ADDENDUM NUMBER: 5
PROJECT: **UNC Charlotte Residence Hall Phase XIV - Early Site Packages**

DATE: **March 4, 2015**
OWNER: **UNC Charlotte**
ARCHITECT: **FWA Group**

Early Site Package Pre-Bid RFI #1

Early Site Package Pre-Bid RFI #2

S304

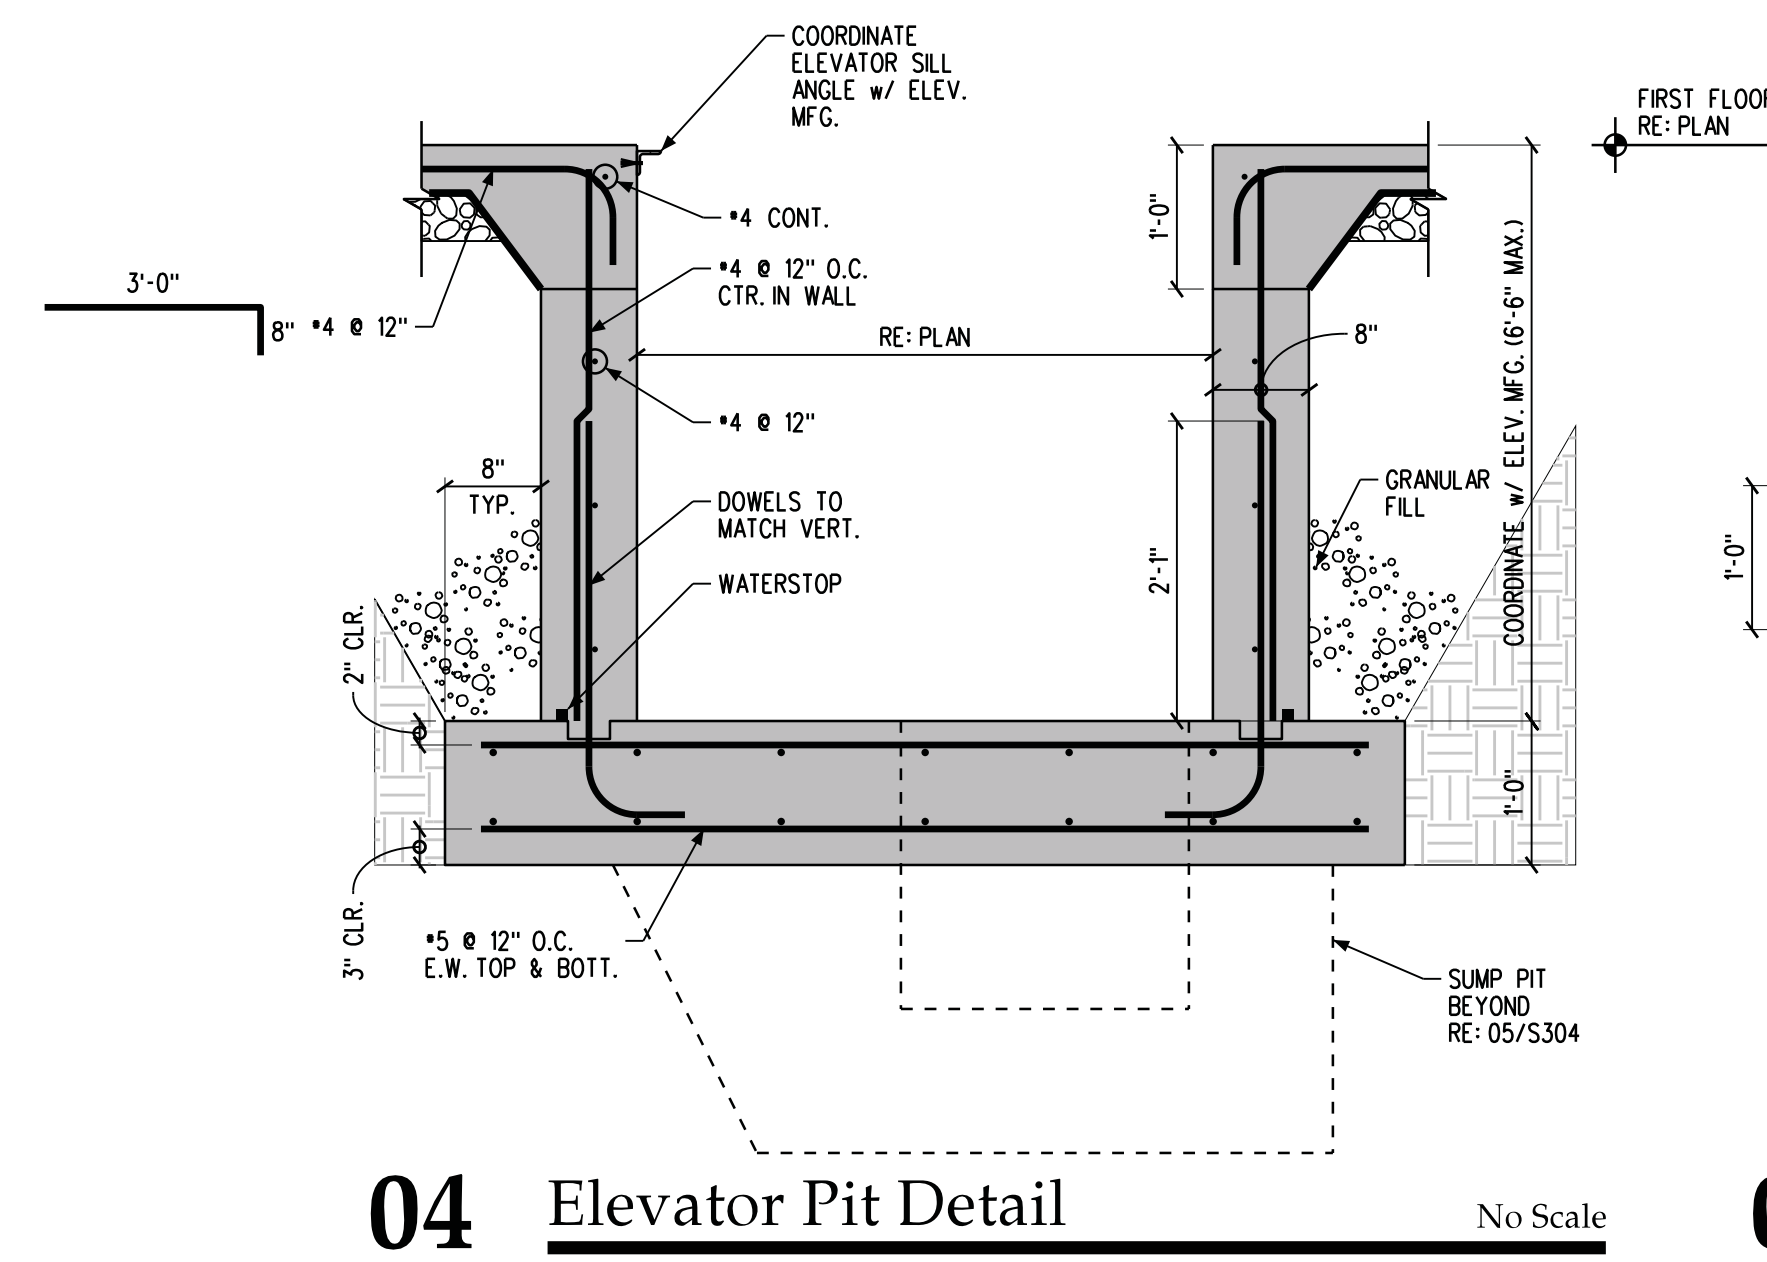
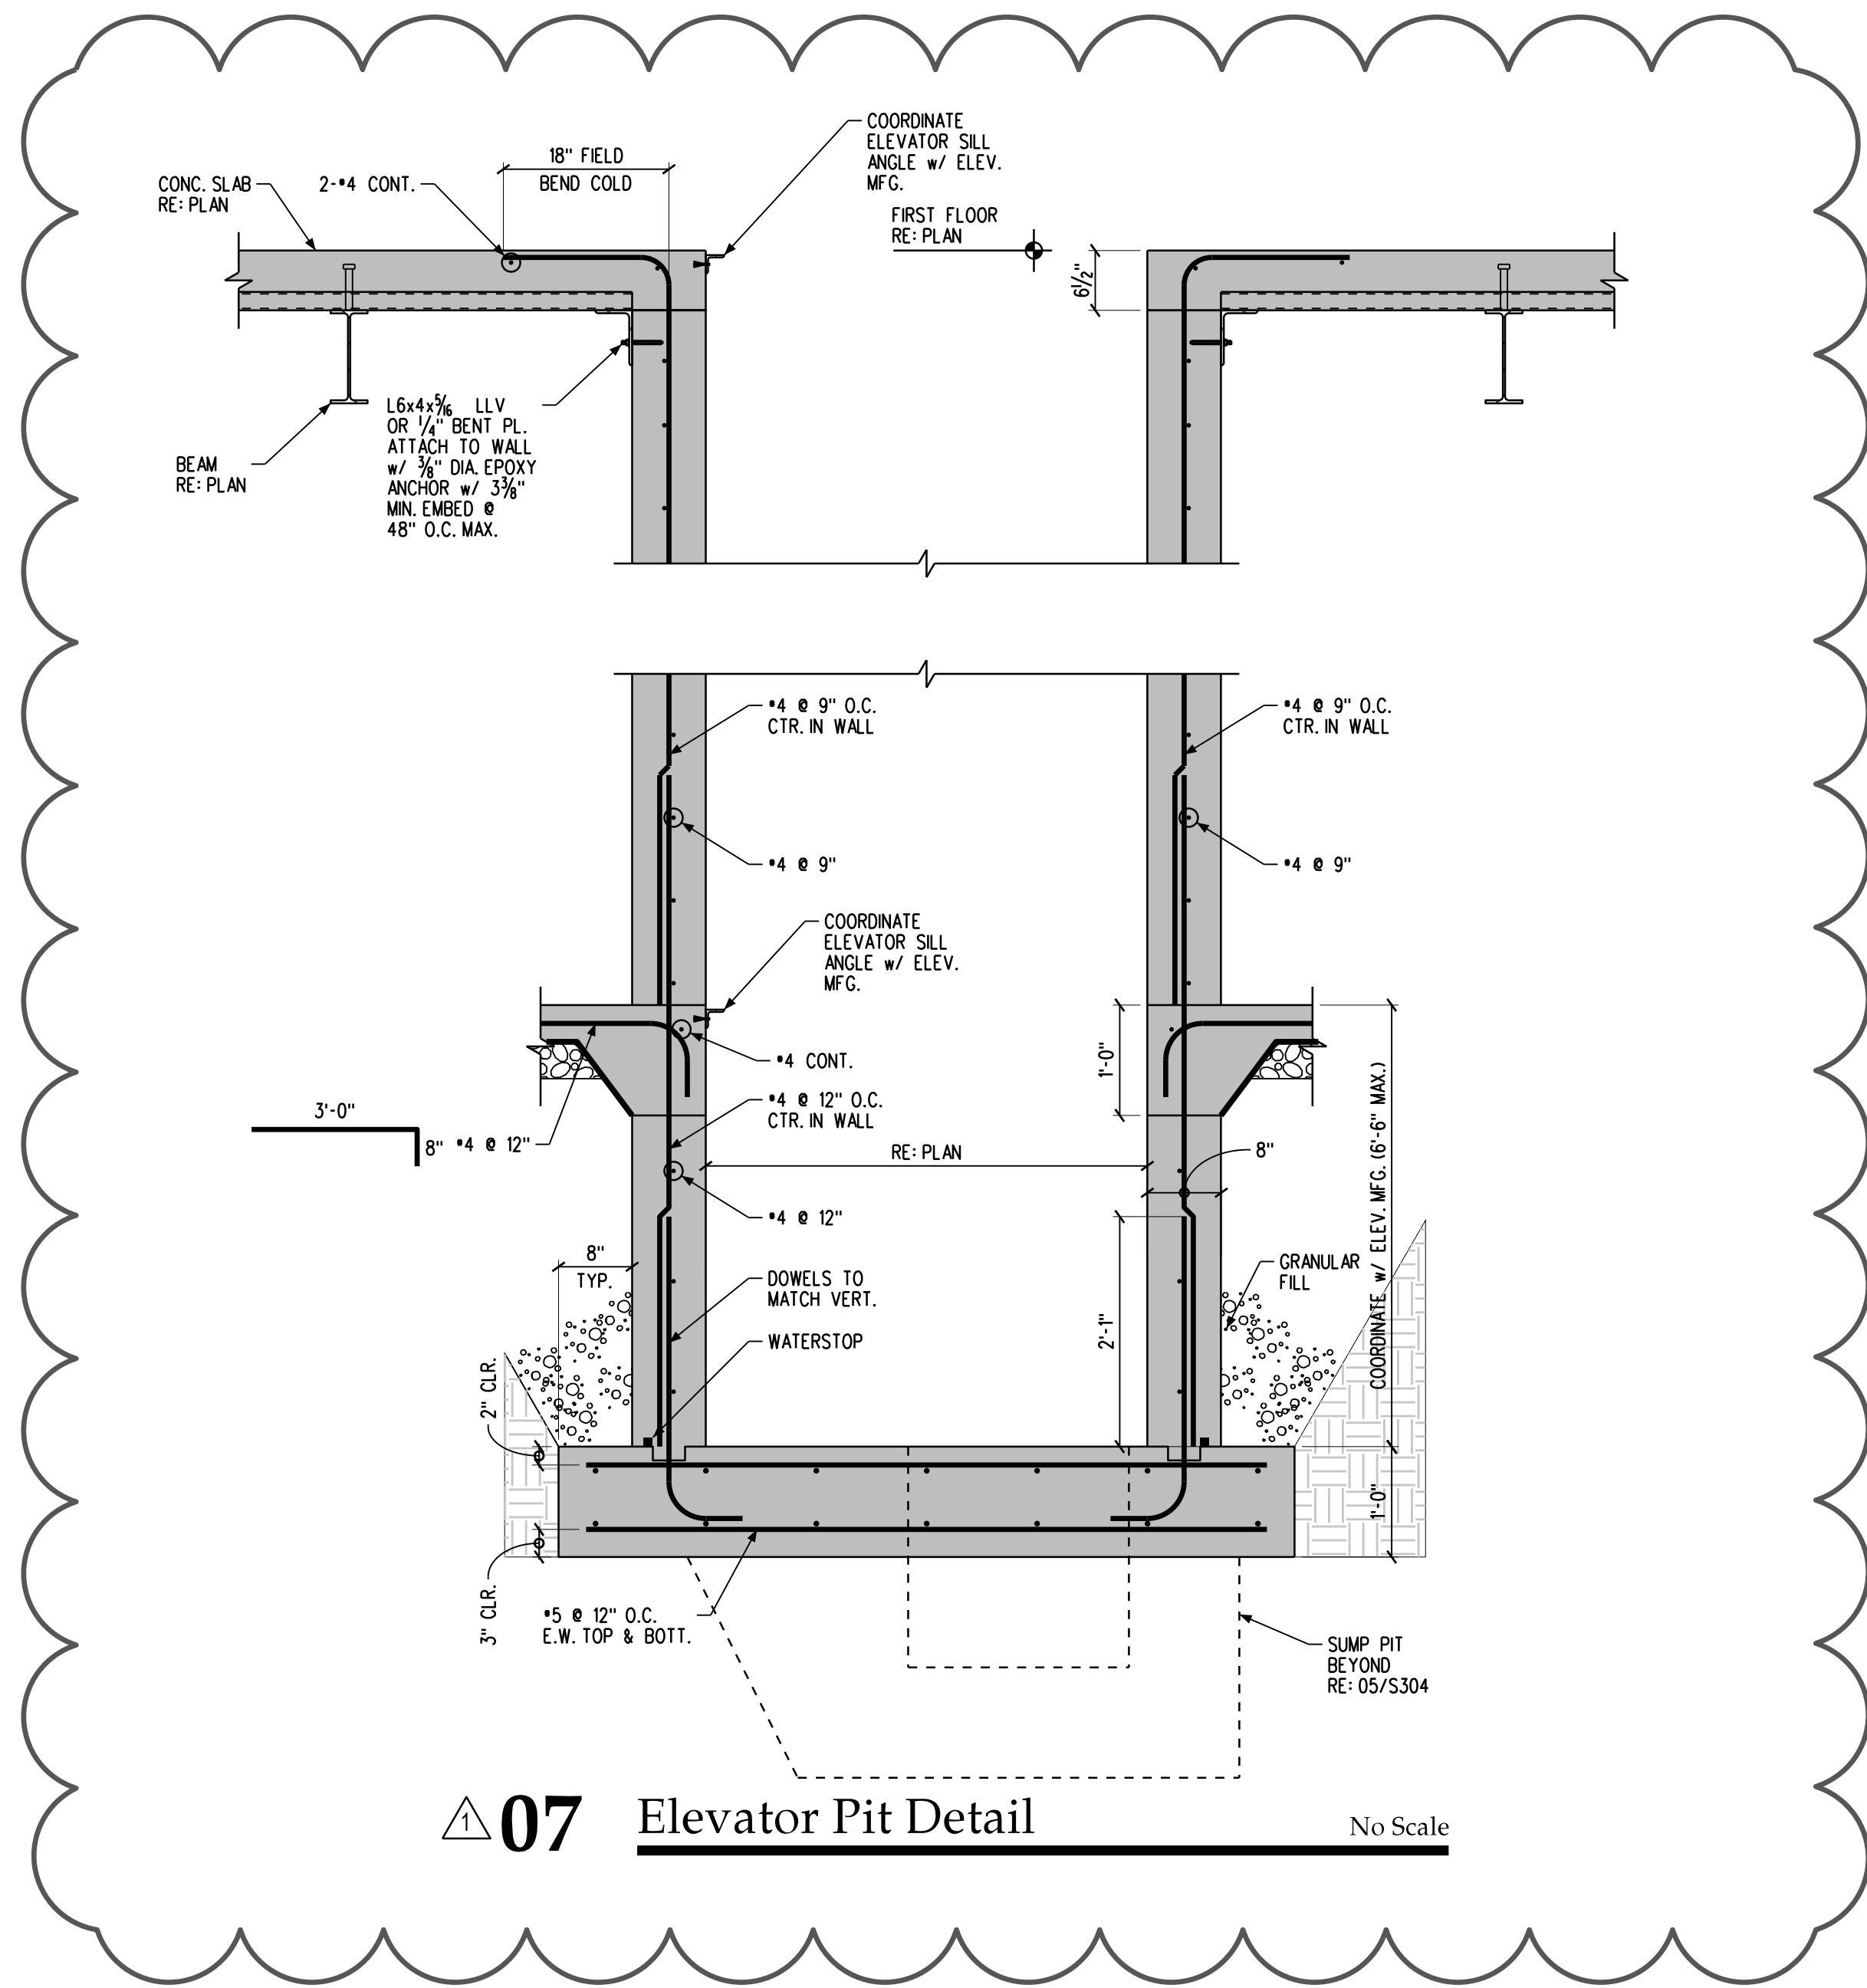
Answer:	FWA Response: Interior waterproofing is not required. The exterior walls of the Central and South Elevator pits are to receive waterproofing per specification 07 13 26 "Self-Adhering Sheet Waterproofing" and as indicated on A2/A710 as part of BP03C.
13	S101-N indicates section 18/S304 at North Elevator Pit- should this be 20/S304?

Answer:	BSDE Response: Details on 01 & 02 on S303 have been revised to eliminate the reference to "first floor". See FWA Addendum #02.
15	Please verify height of central elevator pit walls on S101-N. Section detail 4/S302 shows max height of 6'-6" and does not show a concrete wall extending above slab on grade. However, S201-N indicates a CB1 concrete beam over elevator door at level 1 and the top of adjacent P4A piers are at 731.42. Please confirm if the elevator pit walls should extend to level 1 and provide any required details.

Answer:	BSDE Response: This correction has been made to the drawings. See FWA Addendum #02.
14	Section 2/S303 indicates the top of a foundation wall below the first floor finish floor- please confirm this should be basement slab elevation.

Answer:	BSDE Response: All walls around this elevator extend up to the underside of the first floor. Detail 07/S304 has been added to address this condition. See FWA Addendum #02.
16	Addendum #1, sheet S101-N removed column surrounds in slab leave out areas. Please verify these will not be required in base bid or Alternate #1.

SITE WALL DETAILS

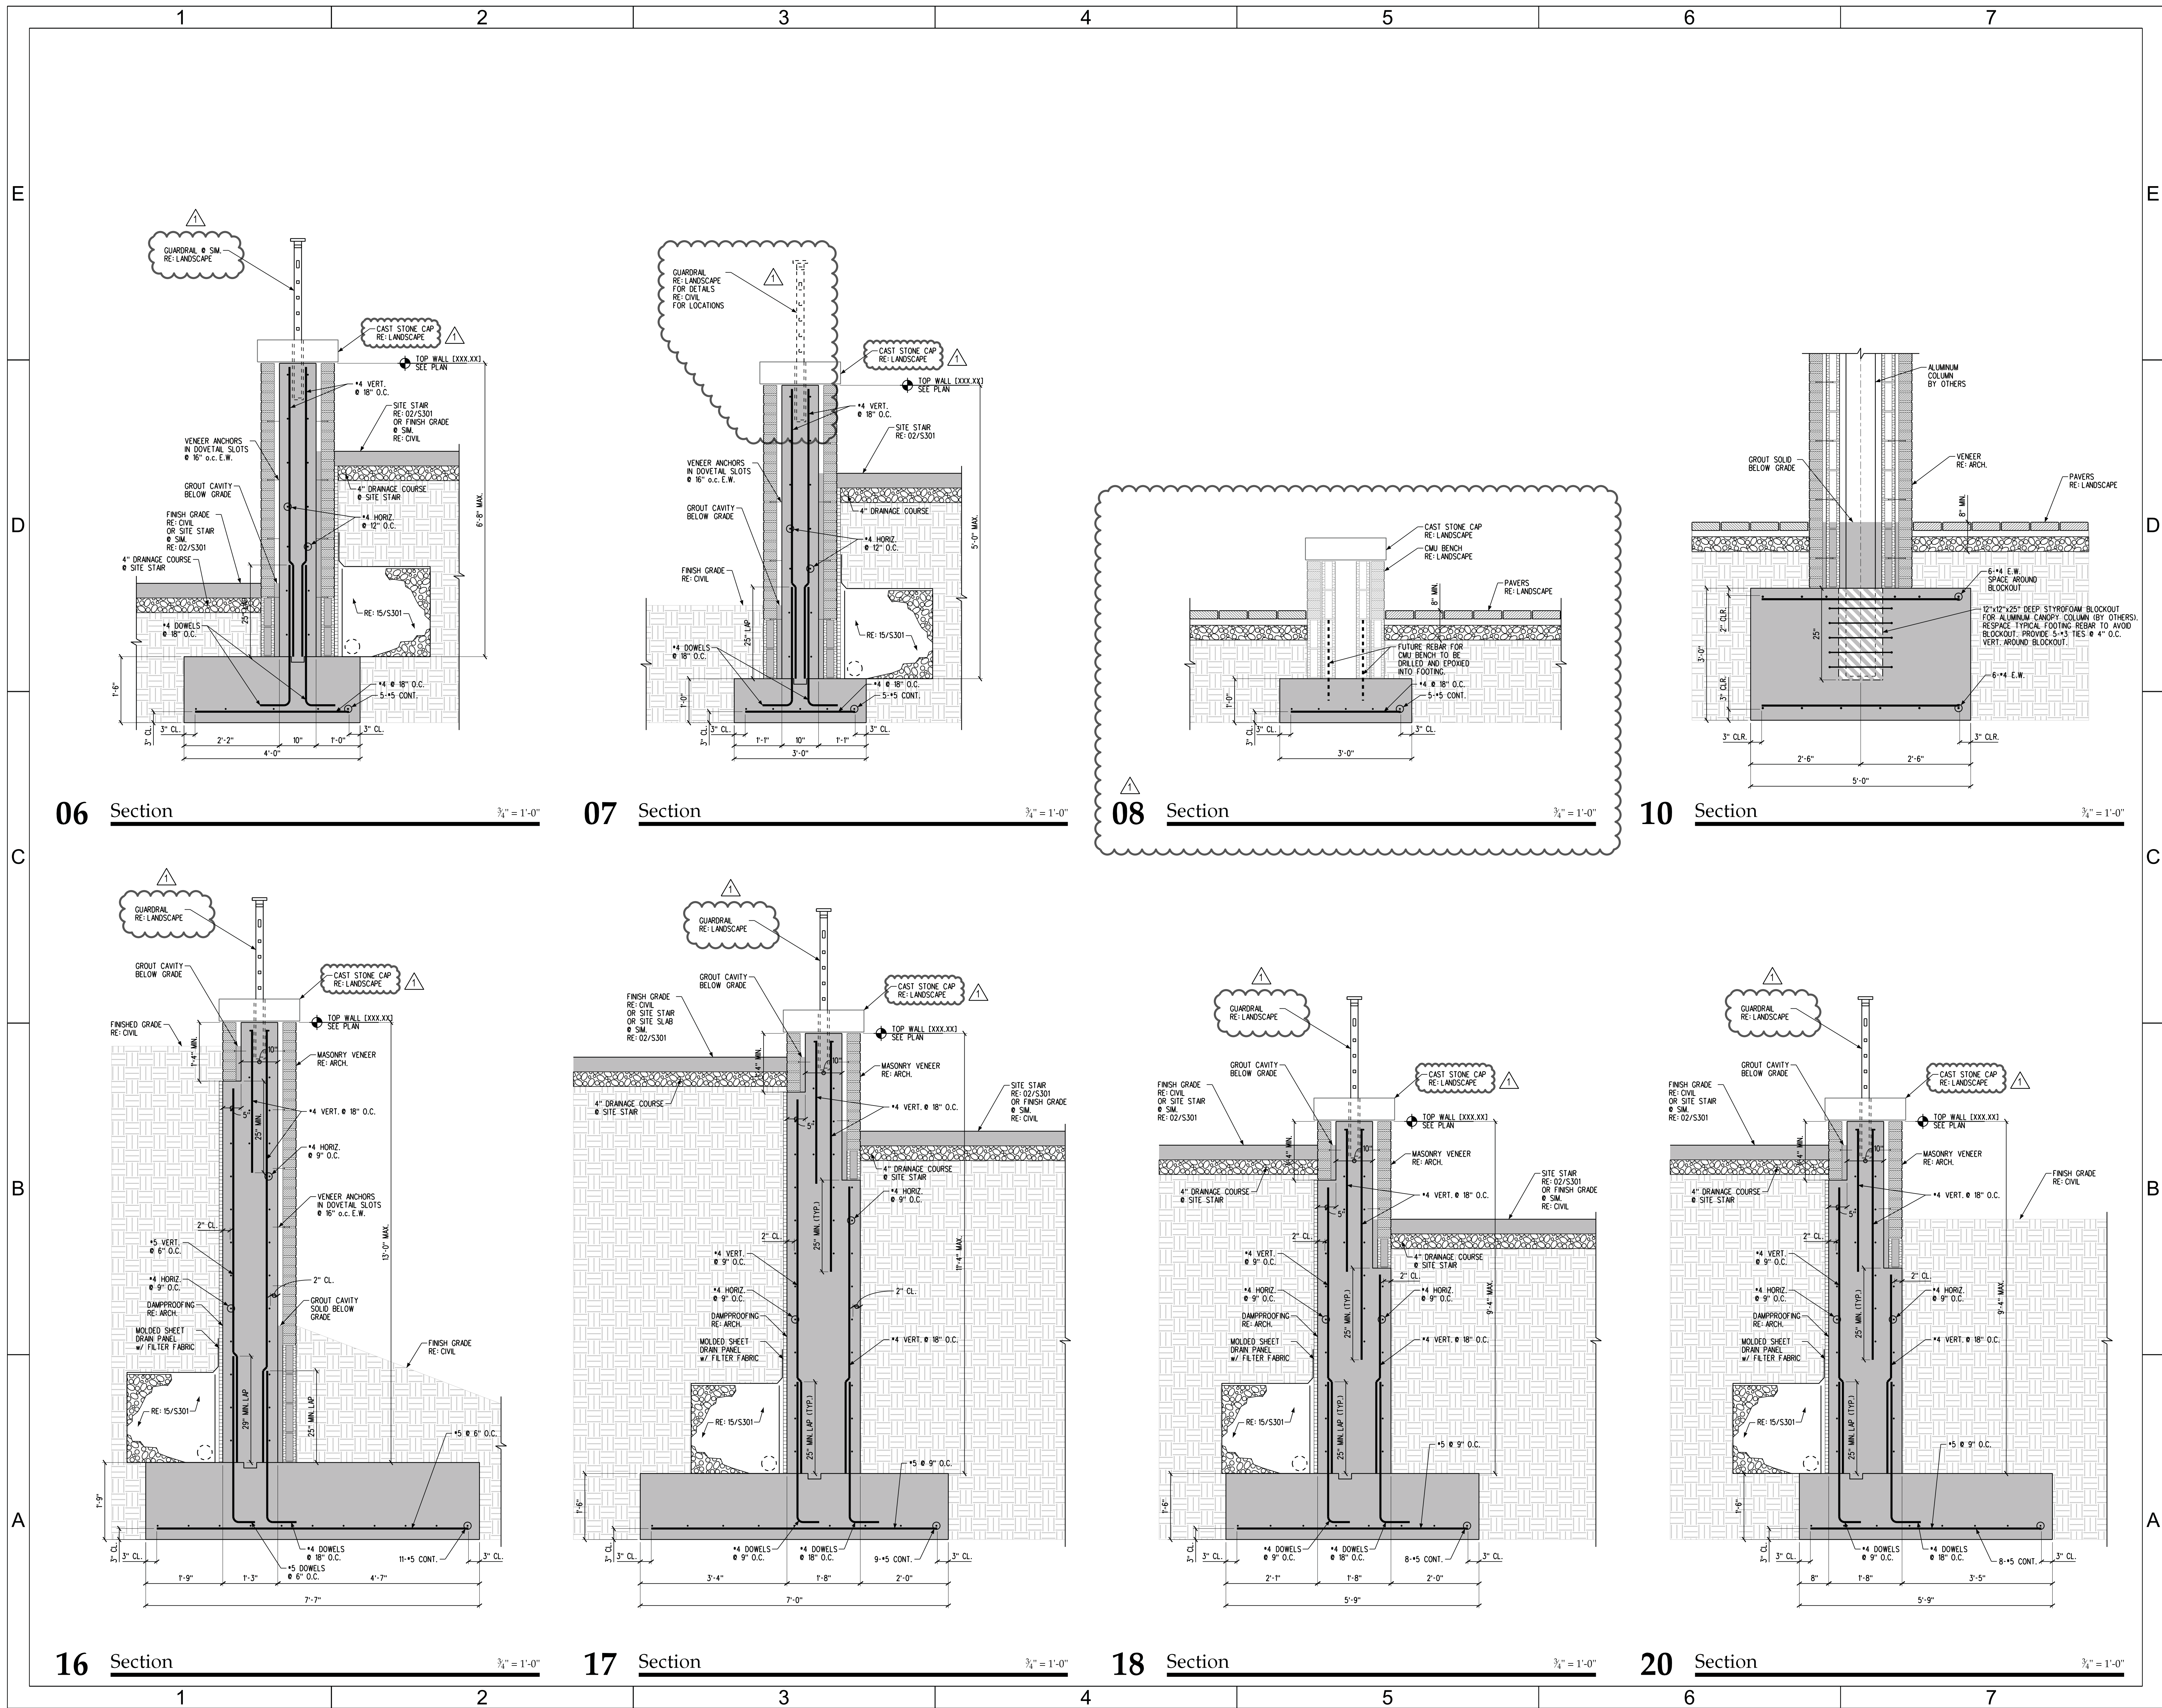
21	BP03C item E01 states we are to include rebar for masonry site walls in addition to the building masonry. Site walls are indicated on sheet S305 and do not indicate any rebar in masonry. However, detail 10/S3.05 which is part of Alternate 14 indicates block that may require rebar but this is not indicated. Please verify no rebar for base bid masonry site walls is required and what to include for Alternate 14.

Answer:	Rodgers Response: BP03C shall not be responsible for masonry rebar as stated in E01, however, BP03C shall provide any dowel outs from concrete assemblies into masonry assemblies as detailed on documents.
22	Please confirm that typical SOG does not require welded wire fabric throughout (in addition to fiber mesh and other reinforcing indicated in specific details).
